ADDENDUM NO. SEVEN

October 8, 2024

Lamont Park Beautification Project

1650.7012.22

P-LA2-CNST-101

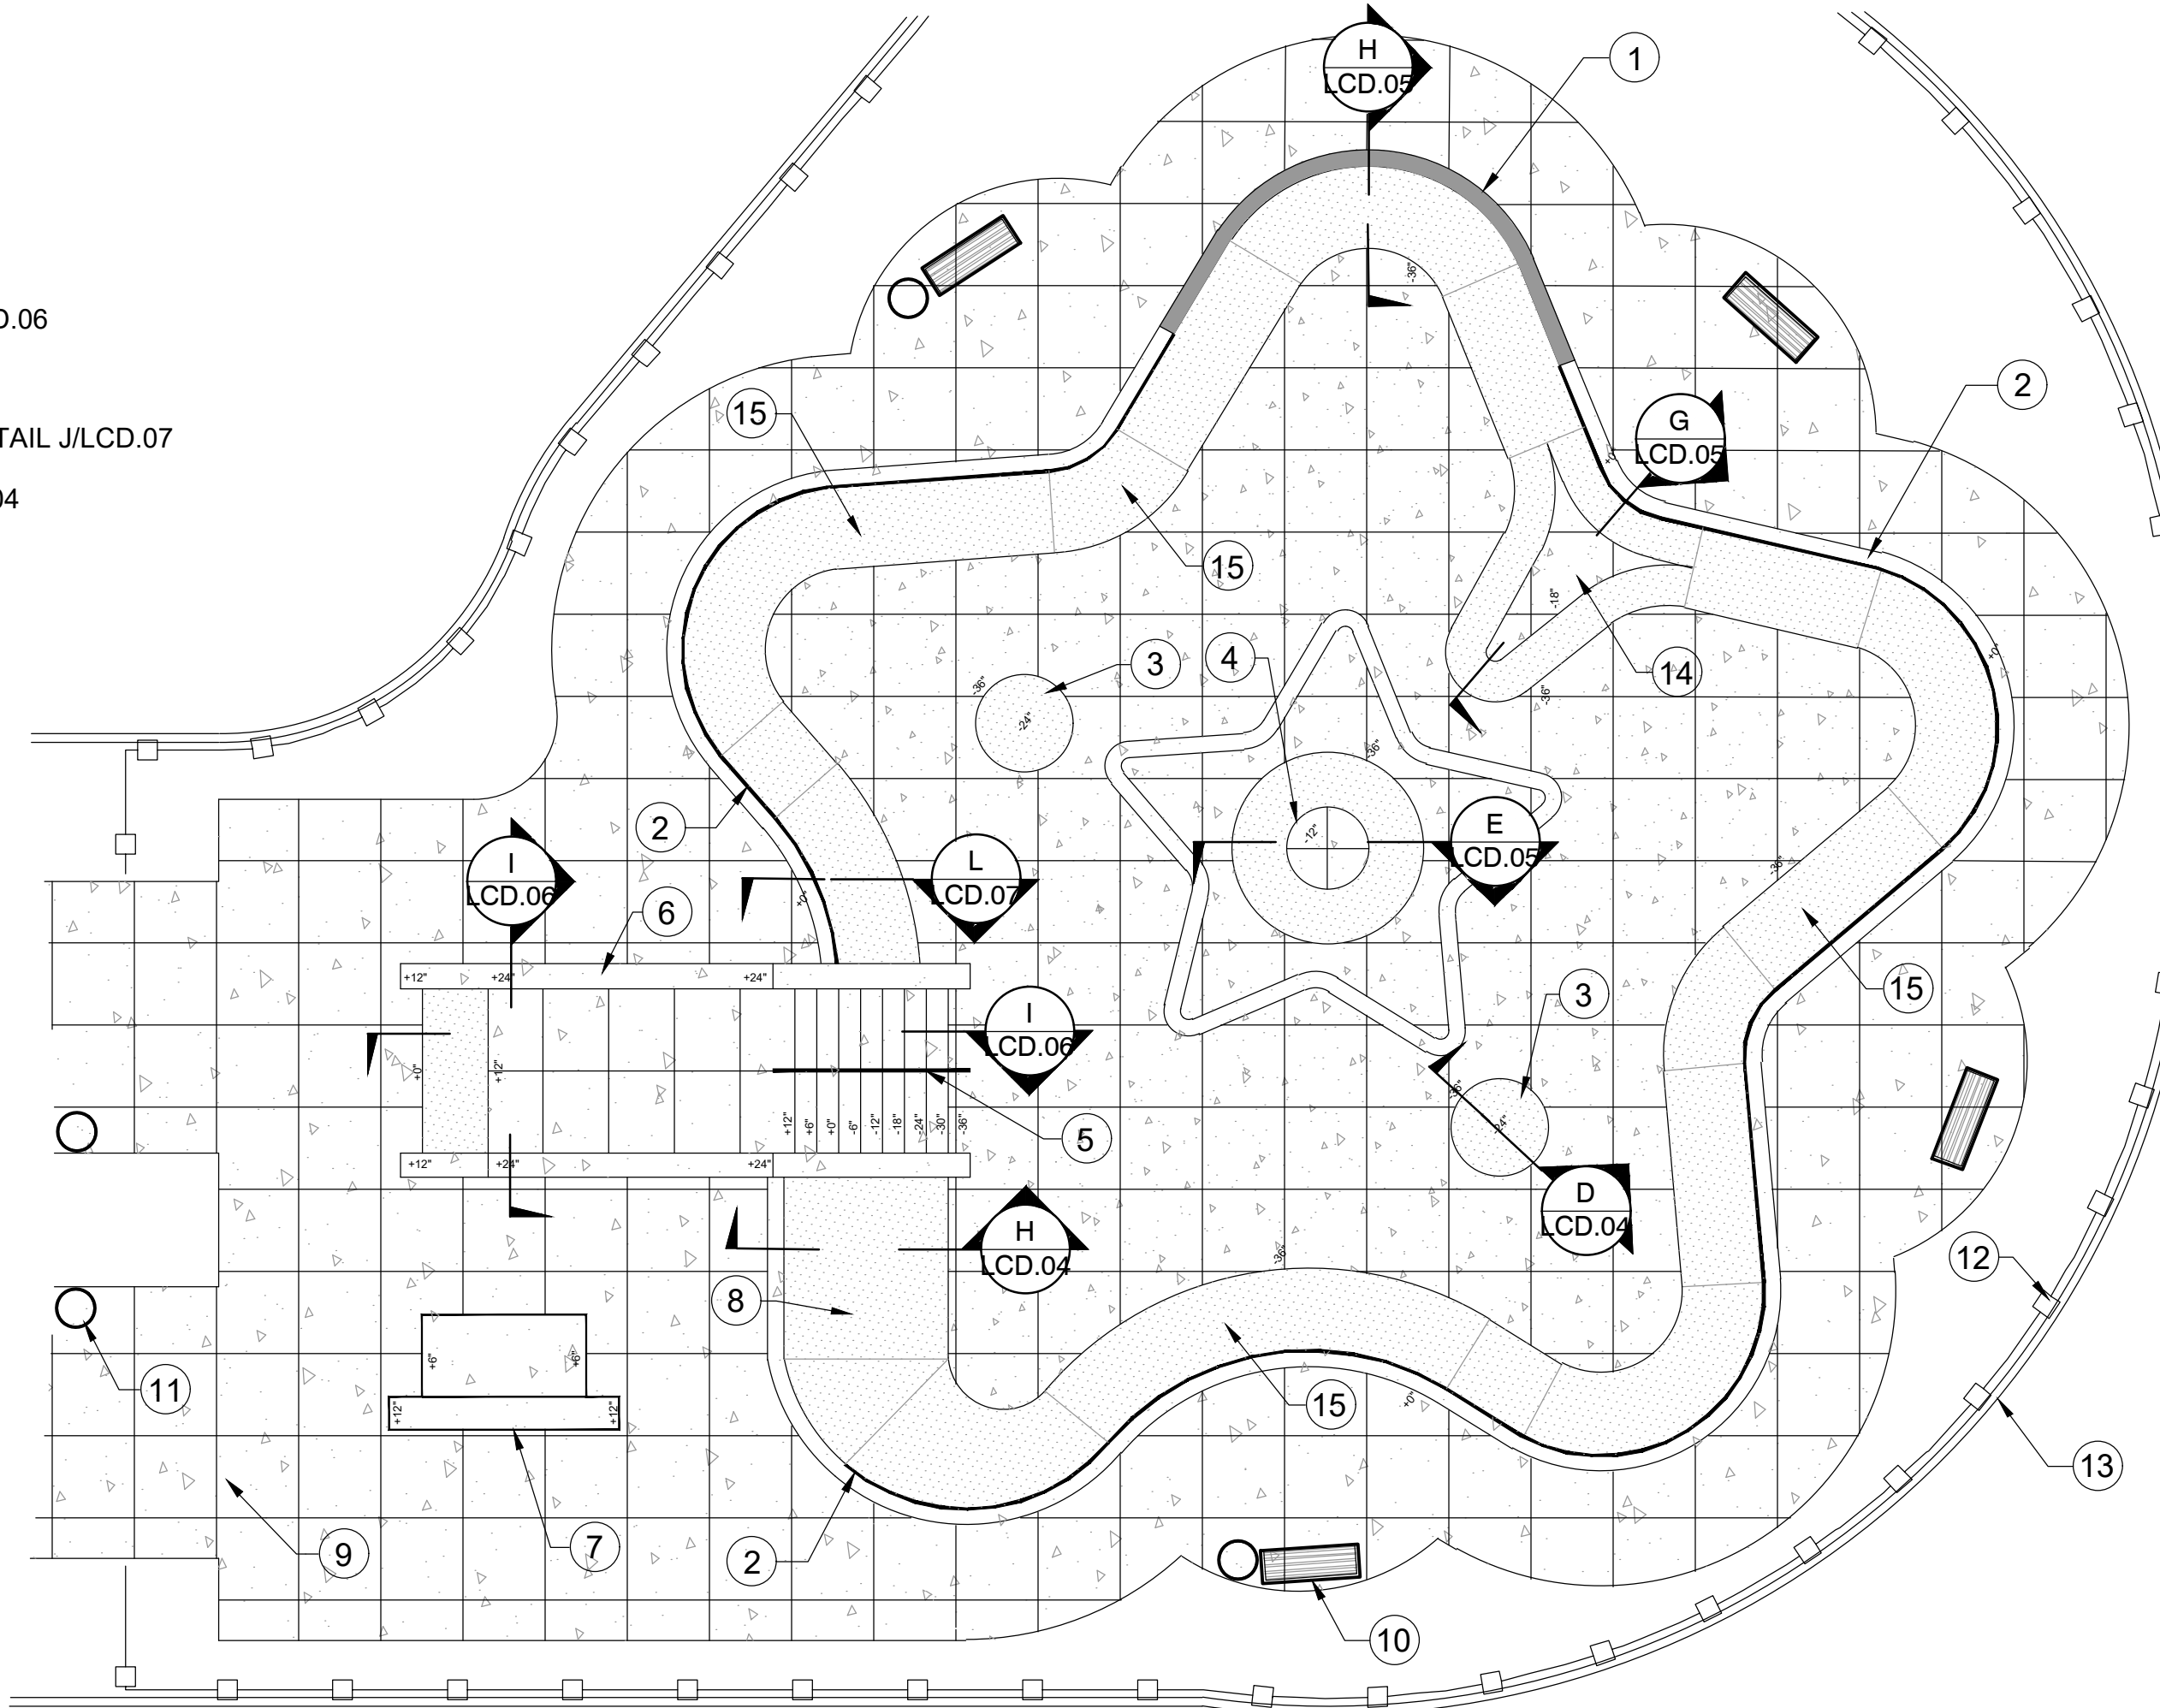
- Item No. 9:** Refer to attached sheet LI.02 and replace existing sheet LI.02 in its entirety.
- Item No. 10:** Refer to attached sheets LCD.04 and LCD.07 and replace existing sheet LCD.04 and LCD.07 in their entirety. Refer to revision clouds for modifications.

JOB	
DP	LCD.05
FM	MM AC
	12 OF 36

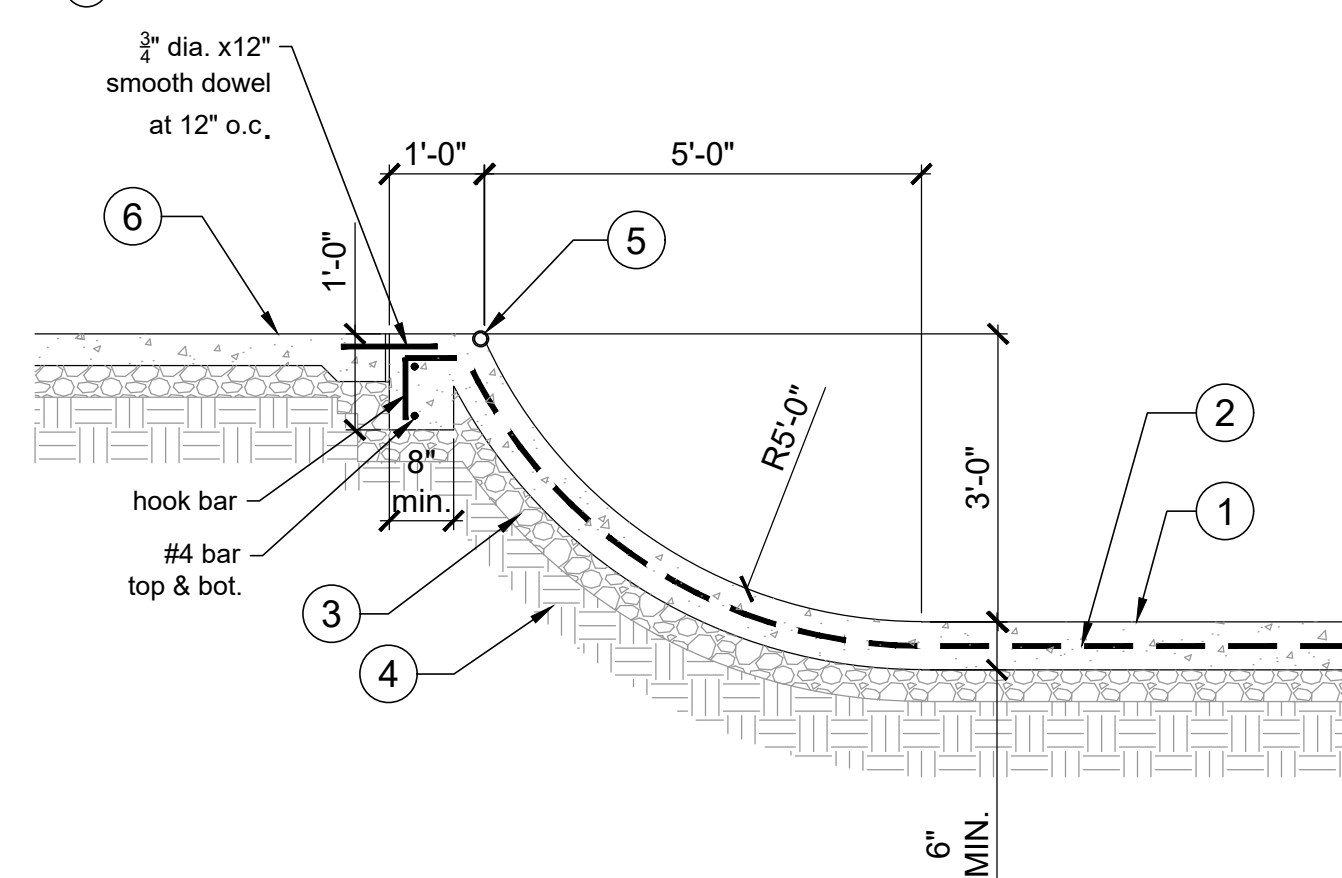
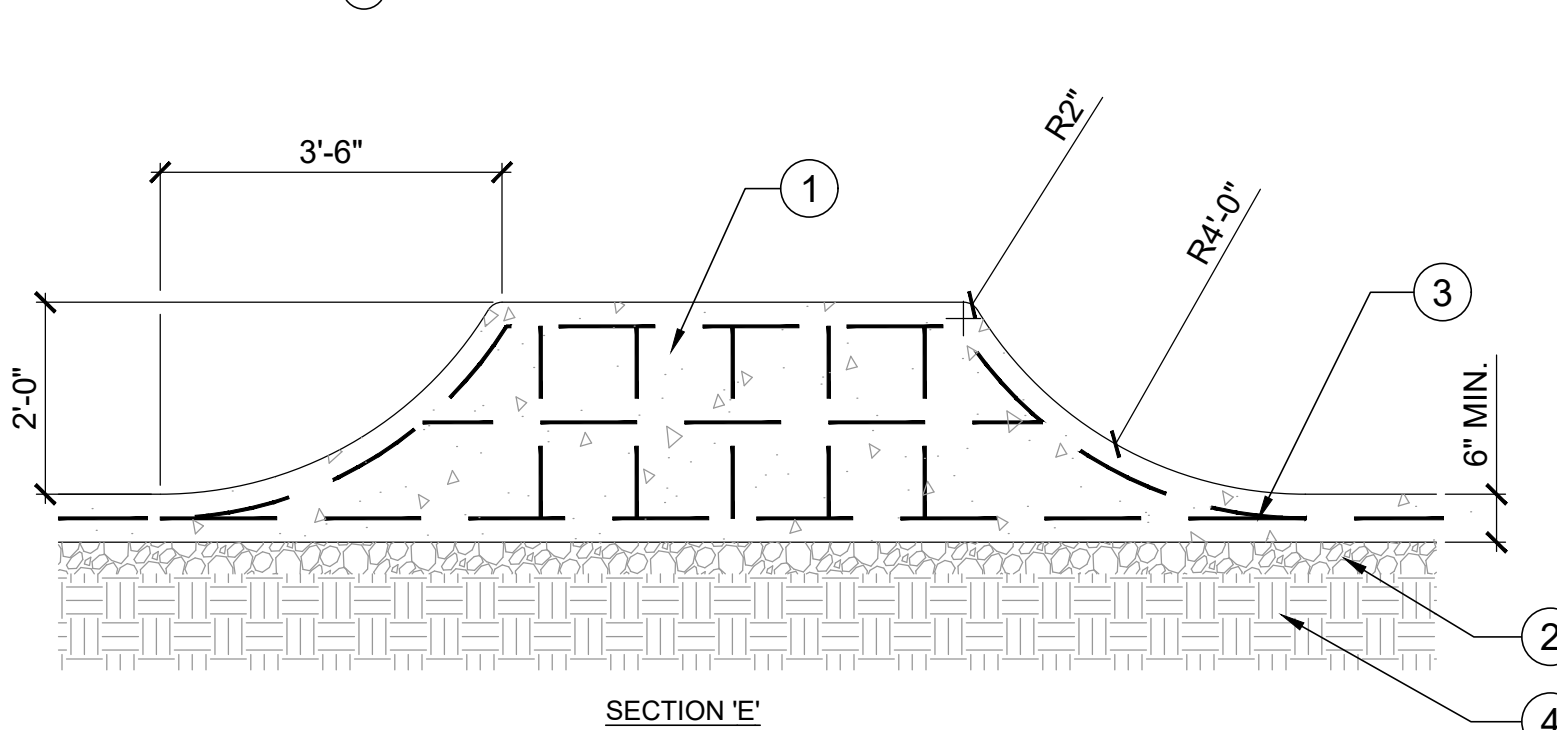
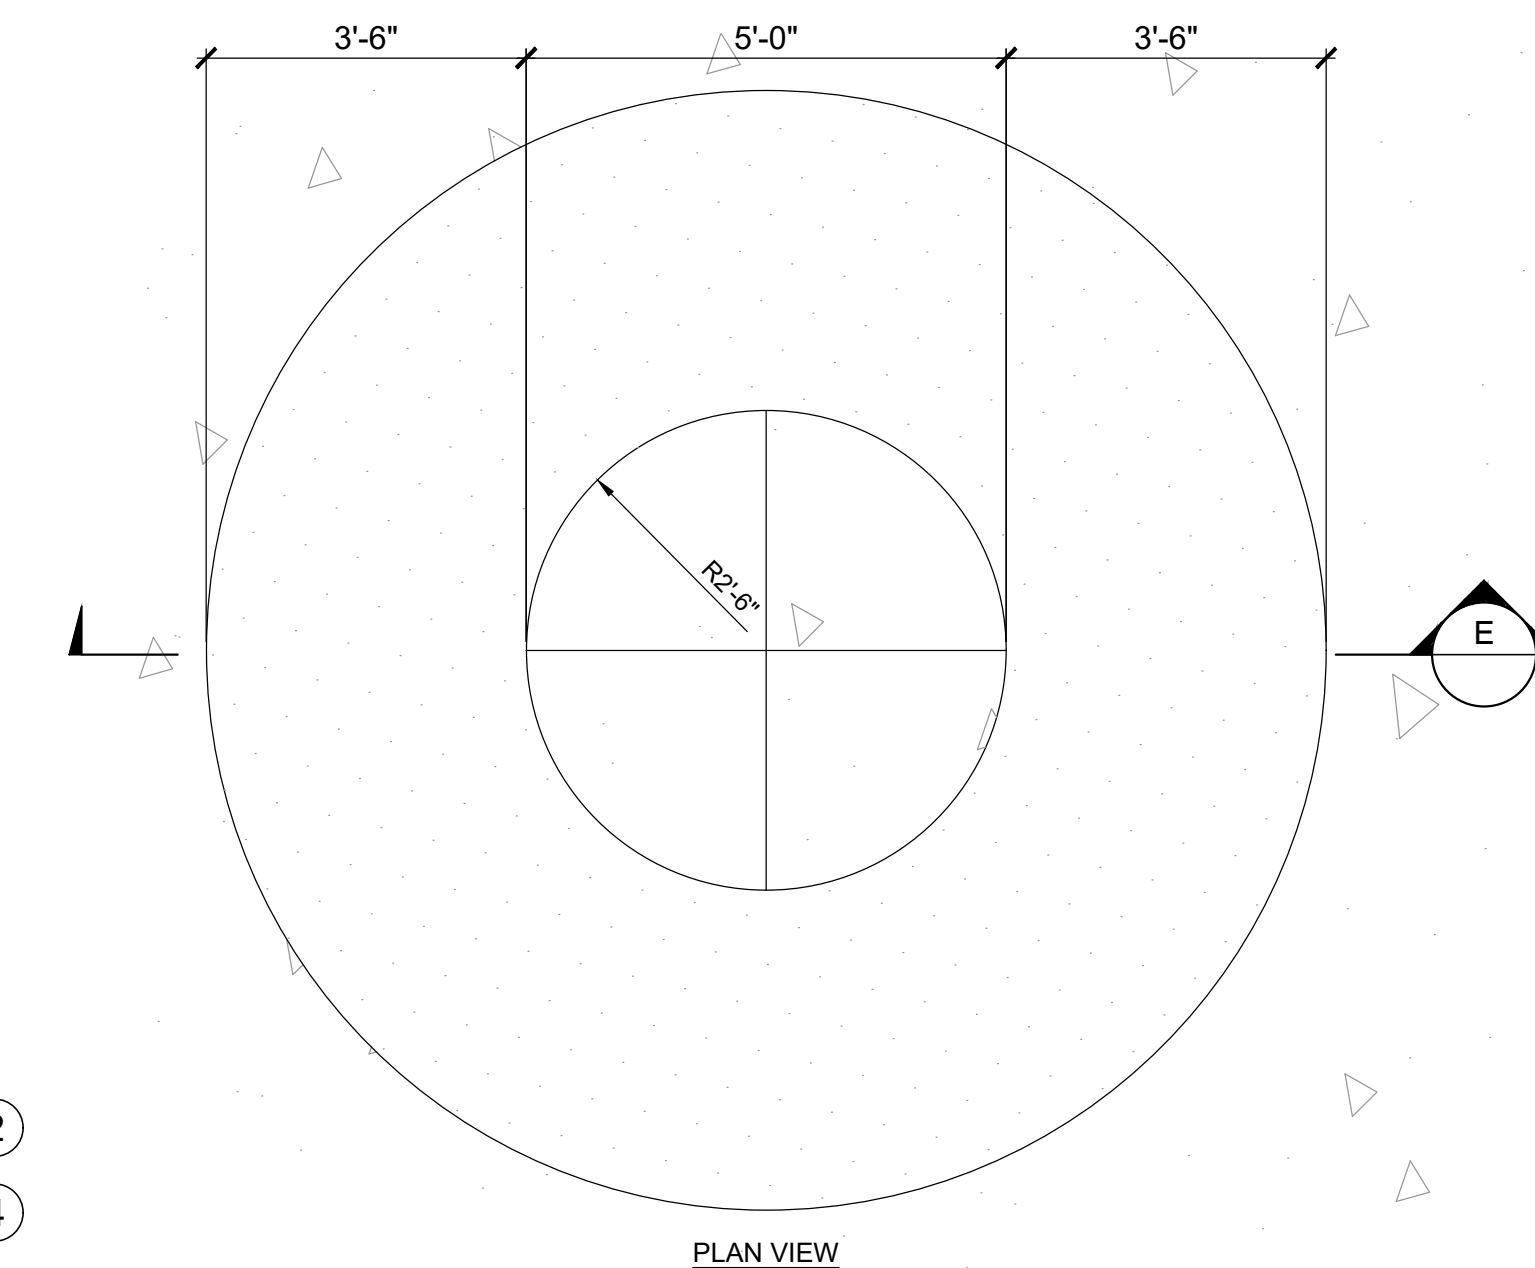
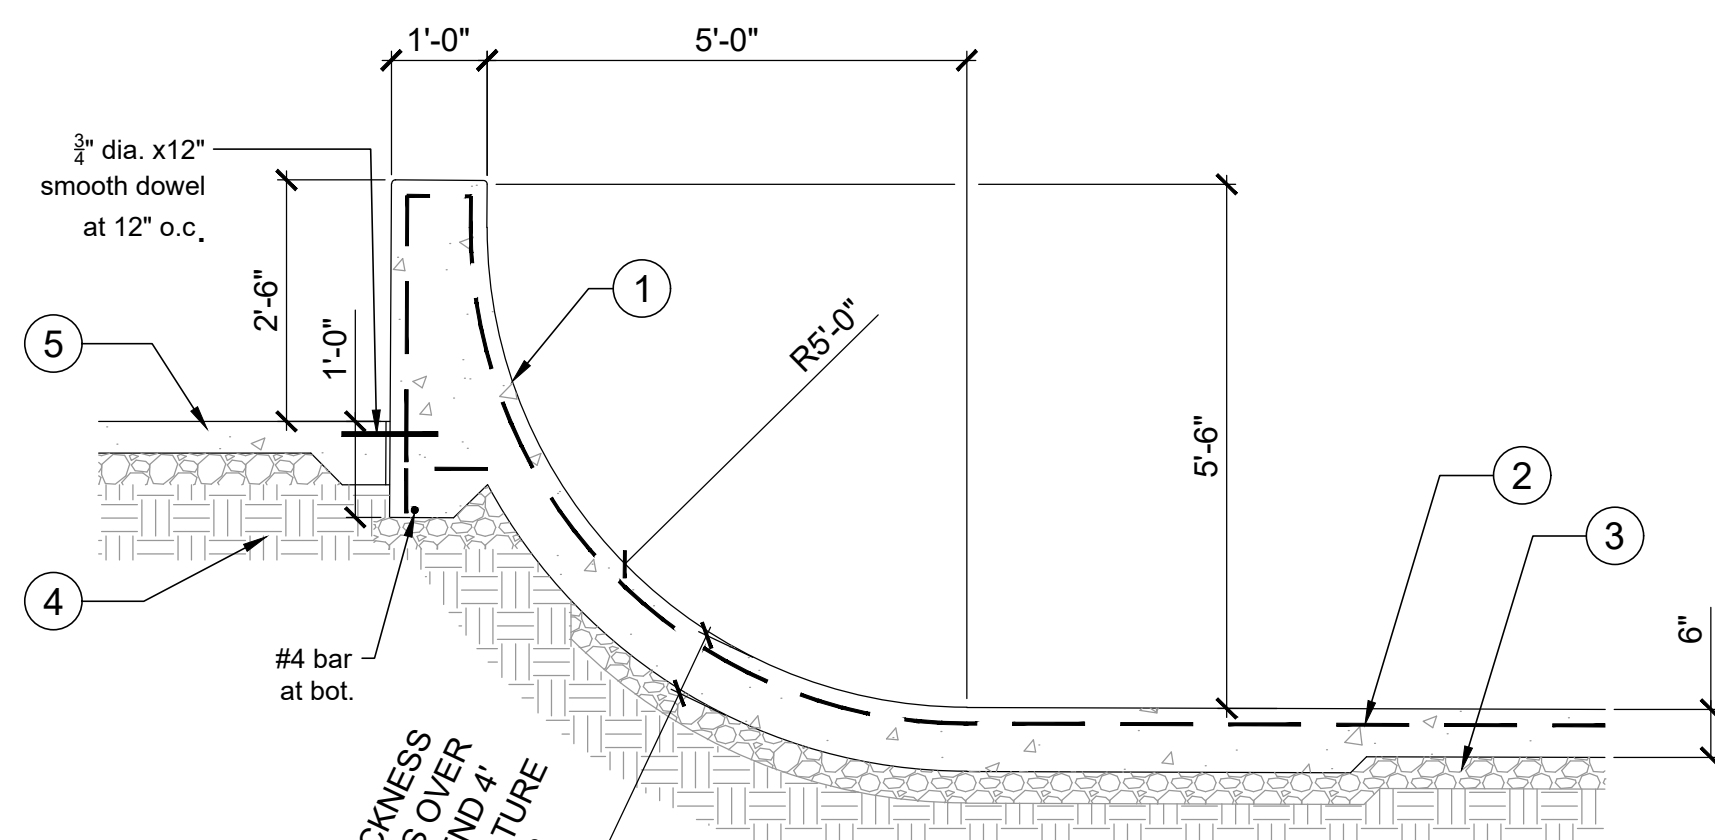
- Item No. 6:** Refer to sheet LCD.09 for details on call out C-04 & C-05.
- Item No. 7:** Shotcrete is acceptable for use on Skate Park.
- Item No. 8:** Refer to attached sheet LCD.05 and replace existing sheet LCD.05 in its entirety. A thickened beam and dowels will be added at the top of the skatepark wall. Refer to details on attached LCD.05.
